Due-Diligence of a Small Hydropower Plant

Case Study Peru HPP

Training Workshop “EBRD: Financing Small Hydropower Plants in Ukraine”

Main results of the technical pre-due diligence

Tunnel

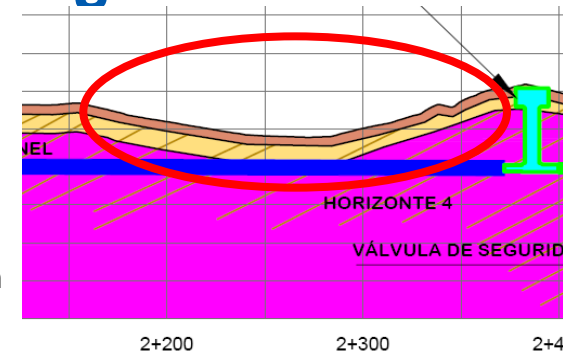
- Right upstream of the surge tank, the topography shows a depression that leaves the tunnel with little covering (approx. 15 m). The boreholes in that zone show presence in depth of highly weathered soil-like material.

- Classification of Rock comprises 4 Rock Classes, 5 would be more adequate.
- Excavation Progress per day considered to be realistic
- Unit Prices for Excavation for Rock Classes I-II probably too low, for Rock Classes III-IV adequate.

- In geological Classification of Rock no transition between Class II and IV considered. Class III in between necessary, probably leading to higher costs for tunnel excavation.

- Section between surge tank and penstock considered to be Rock Class II. This appears rather unlikely and it is recommended to set up Class III or IV.

- Distribution of Rock Classes along the tunnel routing: 75% Class II, 16% Class III, 9% Class IV. 75% Class II is considered to be too optimistic, 50% more realistic, probably leading to higher costs.

- To counteract delays in excavation progress probably further addits have to be established.

- It is recommended to further investigate that area and evaluate modifications to the tunnel design.
- **A Consultant** has already commenced some evaluation of possible alternatives to overcome this problem.

Surge Tank

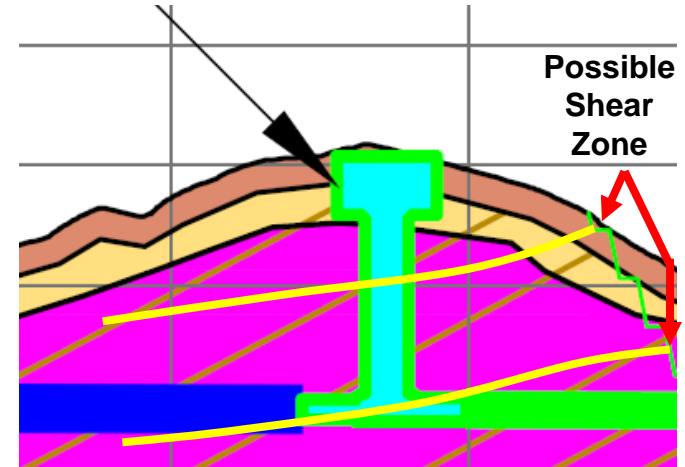
- Drillings have been executed at the surge tank location, up to a depth of approximately 50 m below natural field.
- Results from the drilling show that the hill where the surge tank is planned is constituted by the previously mentioned sedimentary conglomerate.

- The upper part of the conglomerate shows low fragmentation with RQD values around 80%. The quality of the rock decreases in depth where the samples show RQD values between 0% and 30%.

- At the end of the drilling, the quality of the rock increases again.
- Possible explanation for this outcome is the presence of a fault near the hill, which may have shifted resulting on a shear zone.

- The fragmentation and shearing of the rock will complicate the excavation of the surge tank.
- Measures to stabilize the rock surrounding the surge tank could become necessary.

- It is highly recommended to further analyse the activity of the fault, in order to exclude potential future activity

Surge Tank

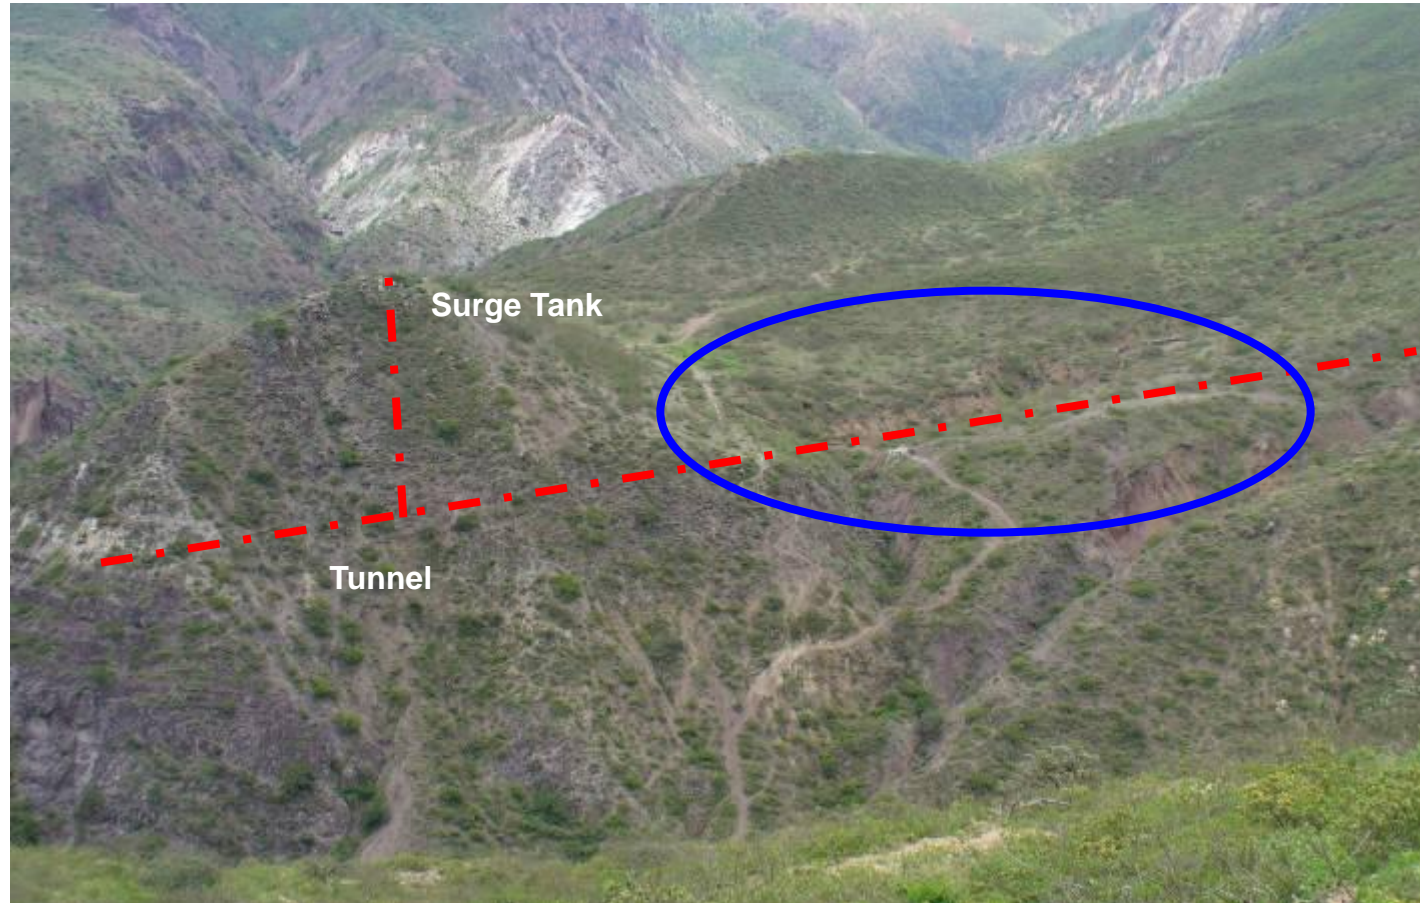
- View of the topographical Depression, upstream of Surge Tank
